Document Number: <u>CY-OC-170-301</u>		Revision: <u>4</u>	
Title: <u>Offsite Dose Calculation Manual for OCS</u>			
<input type="checkbox"/> New	<input type="checkbox"/> Cancel Document	<input type="checkbox"/> Cancel Revision	<input checked="" type="checkbox"/> Revision
EC#: _____		PCR#: _____	PPIS#: _____
<input type="checkbox"/> Editorial		<input type="checkbox"/> Batch	
ER#: _____		AR#: _____	#: <u>IR 787313</u>
<input type="checkbox"/> Supersede corporate document(s) List: <u>N/A</u>			
Revision Summary: Attach add'l descript, if req'd <u>See Attached ODCM Determination Package</u>			
Impact on Operating and Design Margins: Attach add'l descript, if req'd <input checked="" type="checkbox"/> N/A			
CONFIRM that <u>no</u> commitments (i.e., those steps annotated with CM-X) have been changed or deleted unless evaluated via completion of LS-AA-110 commitment change/deletion form and INITIAL [Preparer]: <u>DZO</u>

SUBJECT: Offsite Dose Calculation Manual Revision 4

Change Matrix for CY-OC-170-301 (ODCM) Revision 4

FIGURE D-1-1a: LIQUID RADWASTE TREATMENT CHEM WASTE AND FLOOR DRAIN SYSTEM

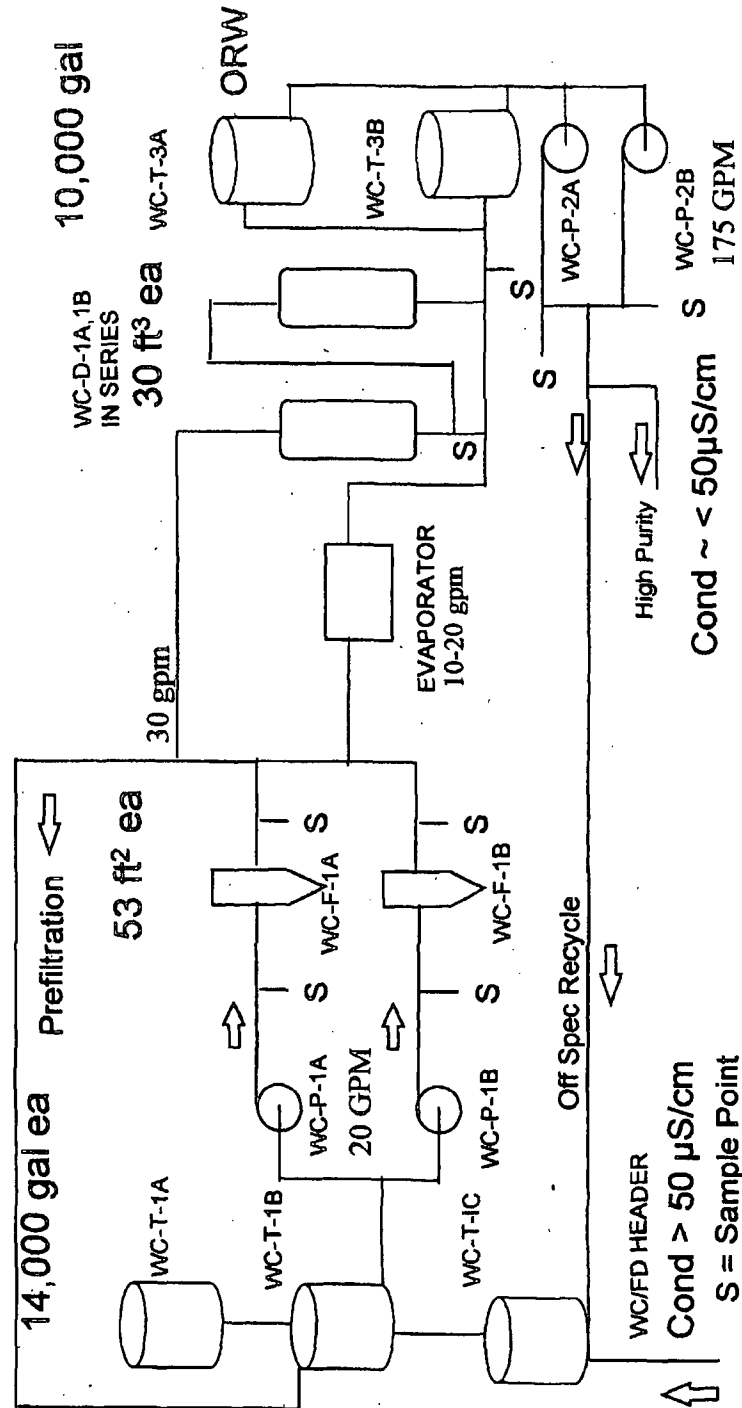
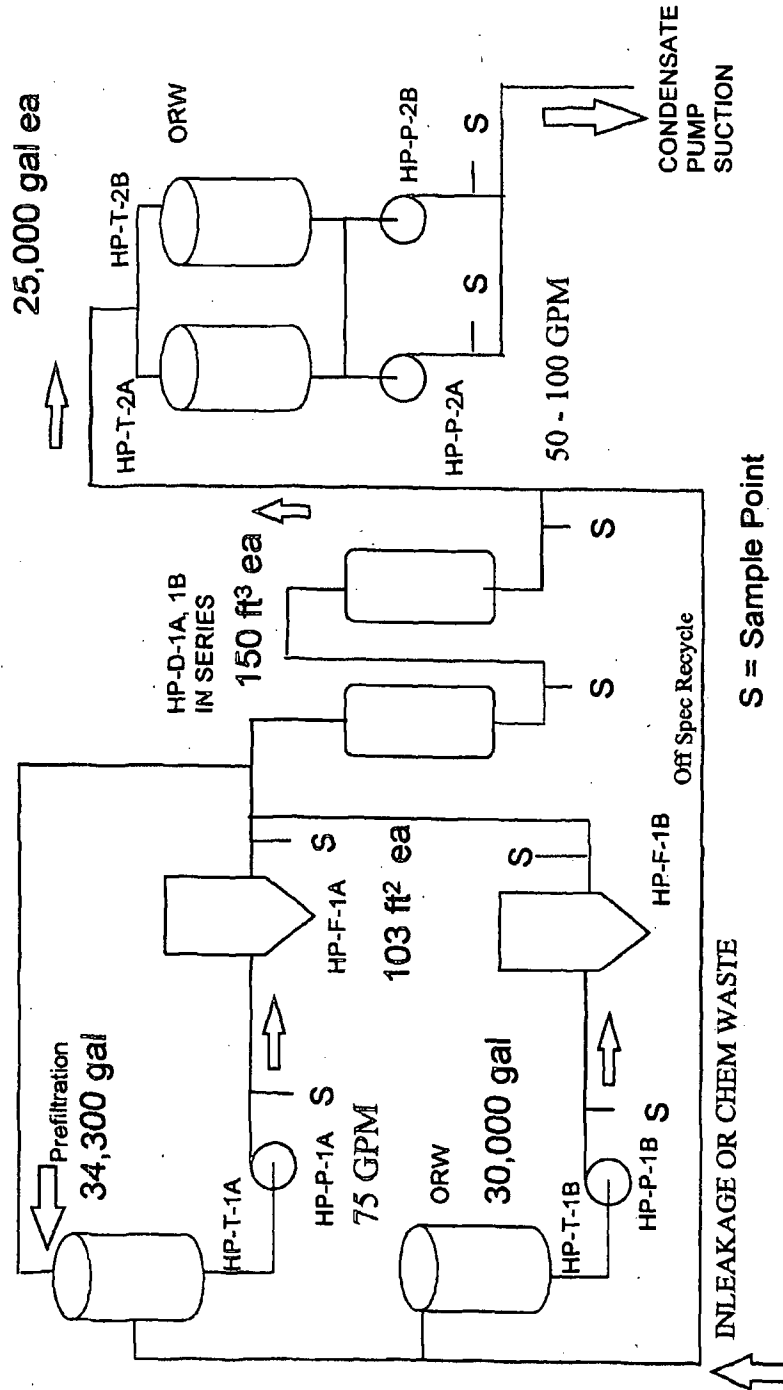
<p>The following was added to Bases 3/4.11.1.3, Liquid Effluent, Liquid Radwaste Treatment.</p> <p>Figure D-1-1a, Liquid Radwaste Treatment Chem Waste and Floor Drain System and Figure D-1-1b, Liquid Radwaste Treatment – High Purity and Equipment Drain System provide details of the Liquid Radwaste Treatment system.</p>	
20	66	65	This administrative change was to add information.	A
21	66	66	<p>The following was added to Bases 3/4.11.2.1, Gaseous Effluents, Dose Rate.</p> <p>Tritium is sampled quarterly for gaseous effluents. Based on the consistency of the data from the quarterly sampling, the sampling frequency is adequate.</p> <p>This change was to justify the current practices at Oyster Creek. NUREG-1302 has tritium performed monthly. The total tritium released in gaseous form was very consistent quarter to quarter for the last seven years. Monthly sampling would not increase the accuracy of the total tritium amount released.</p>	T

FIGURE D-2-2: VENTILATION SYSTEM

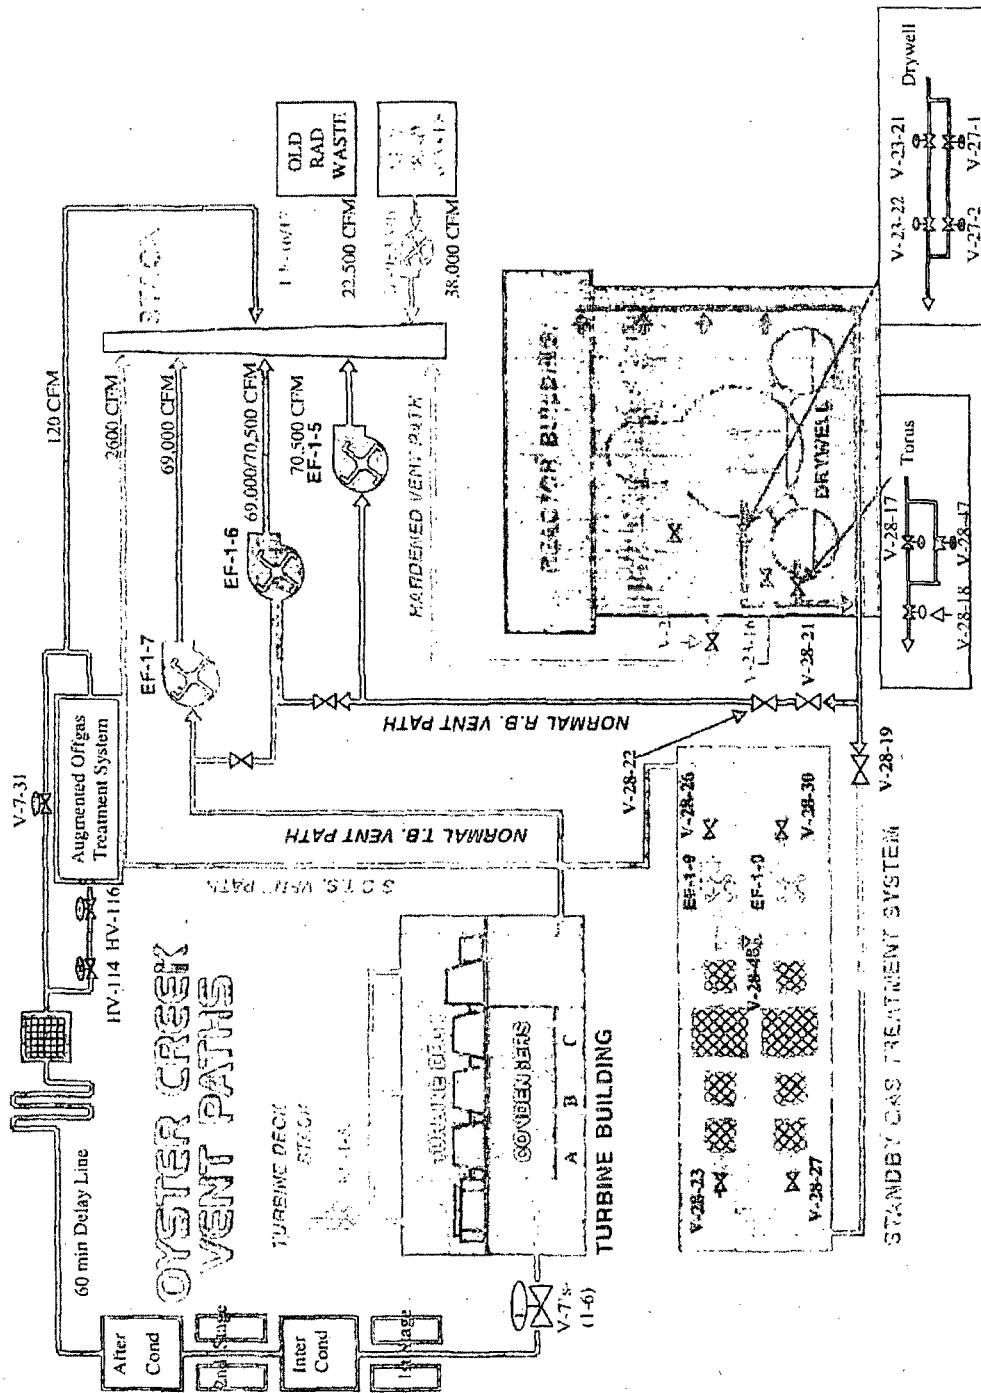
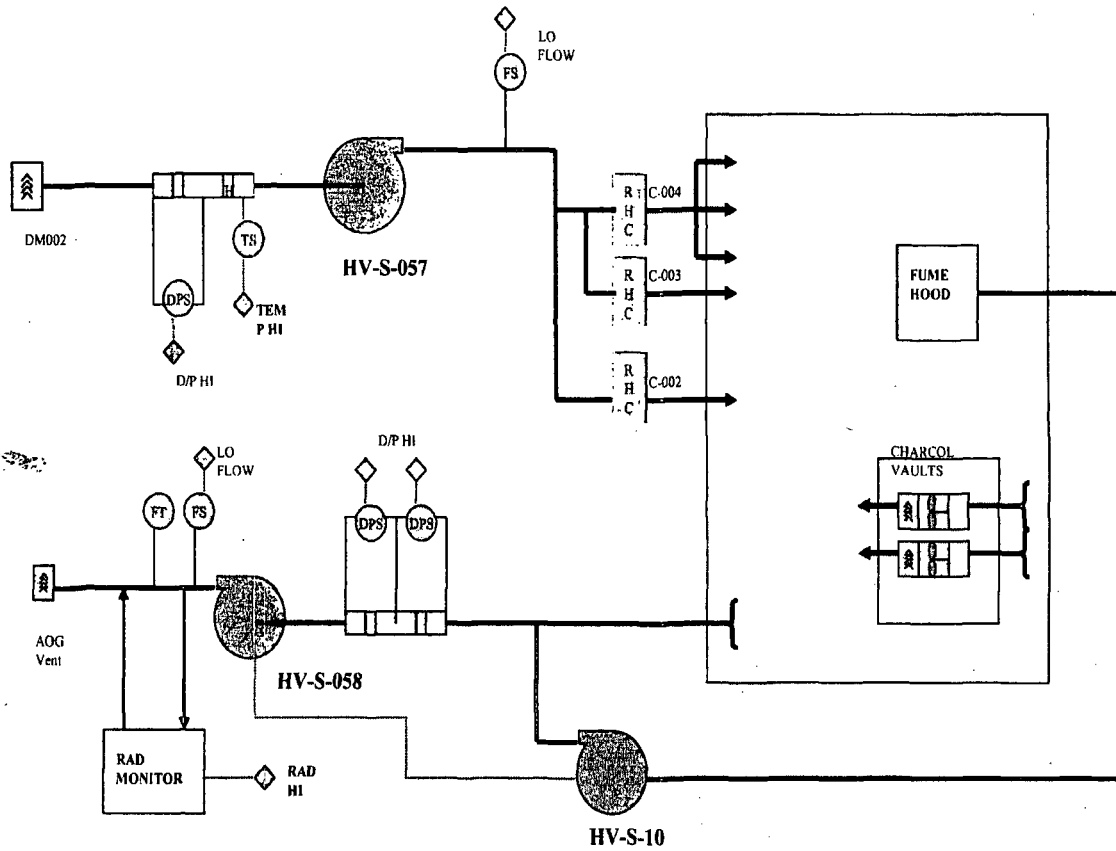
22	67	67	<p>The following was added to Bases 3/4.11.2.4, Augmented Off Gas Treatment System</p> <p>Gaseous Effluents, Augmented Off Gas System. Figure D-2-1, Gaseous Radwaste Treatment – Augmented Off gas System, Figure D-2-2, Ventilation System provide details of the Augmented Off Gas Treatment System and Figure D-2-3, AOG Ventilation System.</p>	A
